Job 72326181REP1	Truss A1	Truss Type Truss	Qty 4	Ply 1	LG1 HOMES\BLANCO GL RF Job Reference (optional)
---------------------	-------------	---------------------	----------	----------	--

UFP Mid Atlantic LLC, 5631 S. NC 62, Burlington, NC, JMP

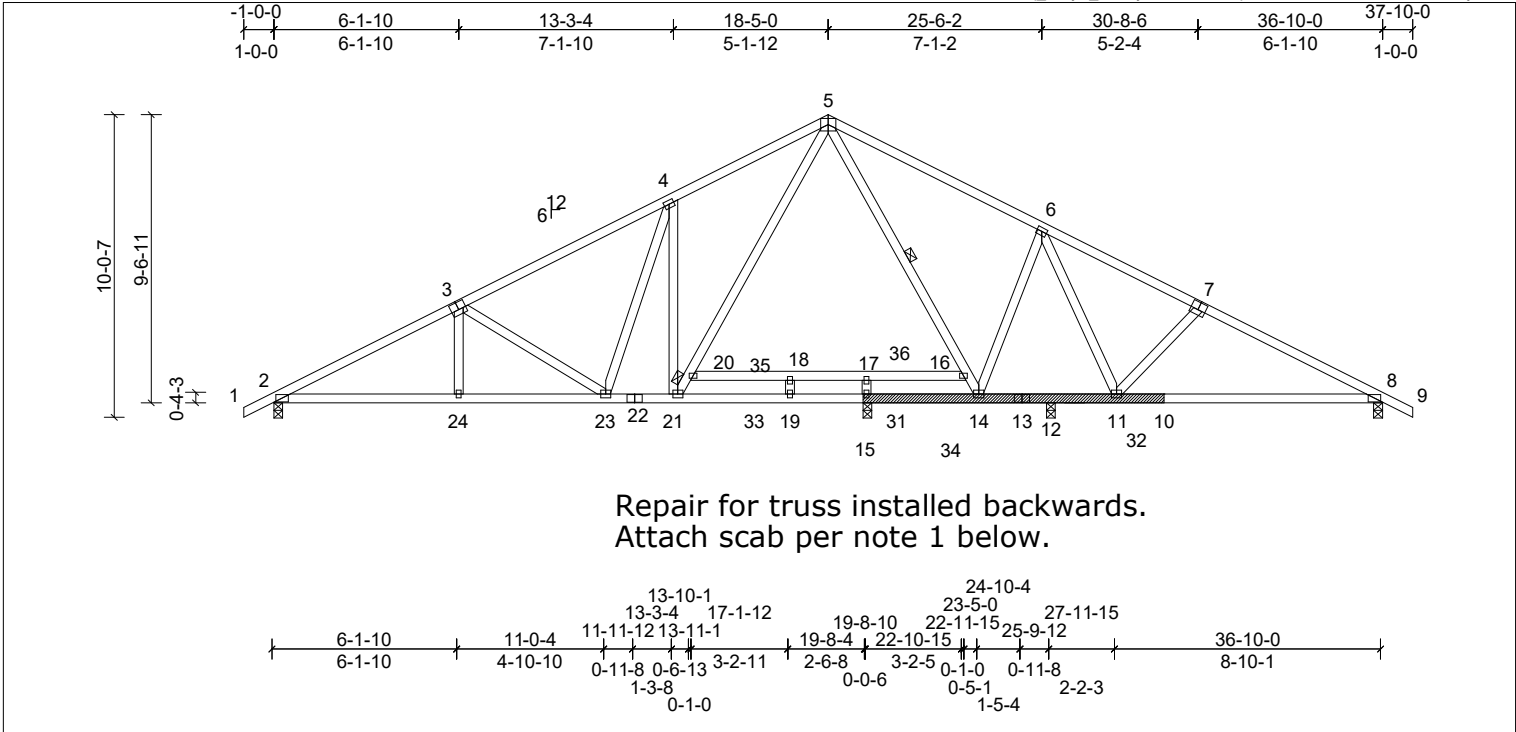
- NOTES (8)**
- Attach 10-0-0 scab 10 to 15, one face 2x4 SP No.2 with 2 rows of 10d (0.131"x3") nails spaced 9" o.c.
 - Unbalanced roof live loads have been considered for this design.

- This repair has been prepared based on information and use conditions supplied by client. Designer has made a good faith effort to outline damage and repair conditions as reported by client. When actual field conditions do not approximate those indicated on this drawing, client shall immediately inform the engineer and refrain from applying the repair.
